PRESSURE SEWER SYSTEM

SUMMARY
GRINDER PUMP LOW PRESSURE SEWER SYSTEM
for
STONEBRIDGE PARK

Re: Stonebridge Park
Low Pressure Sewer

REF: STONEBRIDGE PARK-DESIGN REVIEW

STONEBRIDGE PARK
LPSS DESIGN

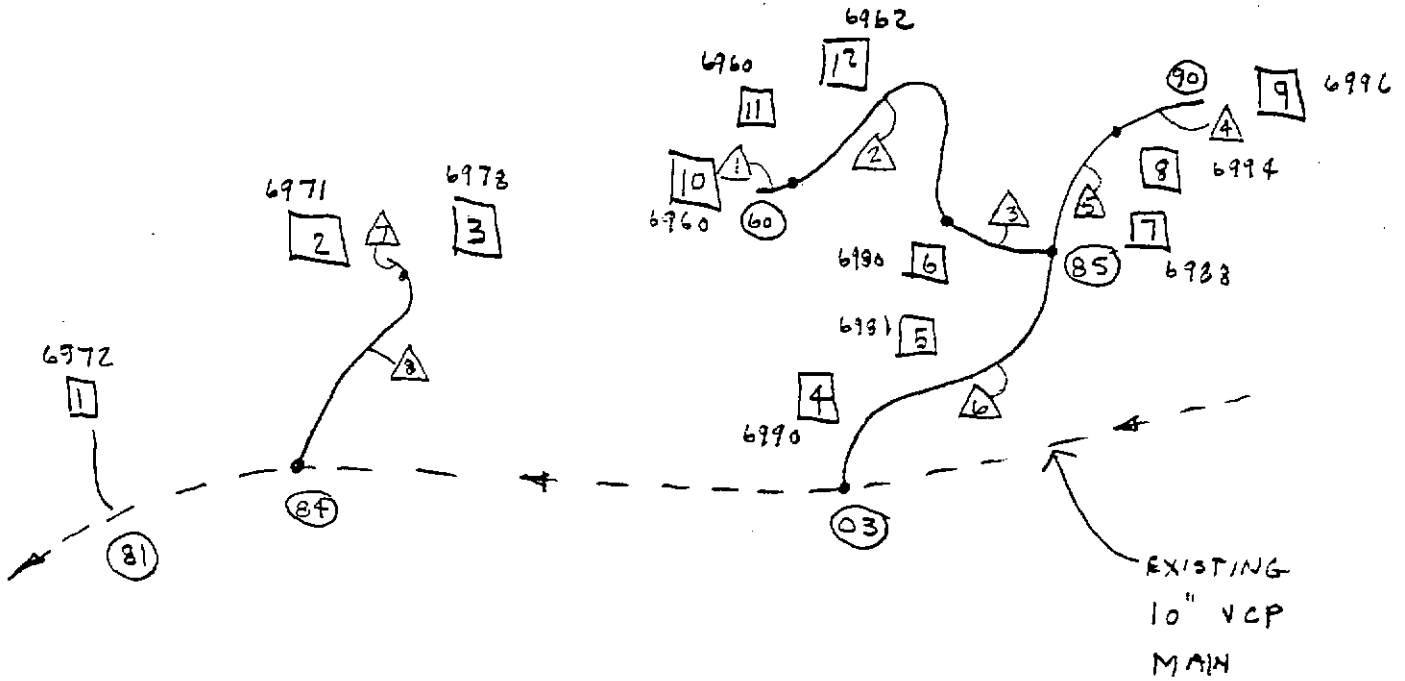
I've added 20% equivalent pipe length for minor fitting losses-is that reasonable?

Do we need to take any special precautions if some units don't get built for a few years?
Seems like the service laterals and upstream lines may get some very old sewage buildup.

I have reviewed your design calculations and concur with your results. I have also reviewed the drawings and everything looks good. It is debatable whether or not you will need an air release valve on such a small system but I suppose since build out will occur over a few years it is better to be safe than sorry! With regard to your questions:

- The addition of 20% for minor losses makes a conservative design even more conservative. The reason is that since you use the entire length of the main in each zone to calculate friction loss no matter where the lateral ties into the main there is extra friction loss built into the calculations. I ran the calculations both ways and found there to be a less than 2% difference in TDH.
- Yes, I would suggest an annual flush via the terminal connections in zones were build-out progresses slowly. If a lot at the "end-of-a-line" is purchased there will probably be no need to flush. Remember that since curb stops will remain closed until connected to a station, there will not be any dead spaces per say. The exception would be if a home were used only seasonally. In that case, an annual flush as described above would be recommended!
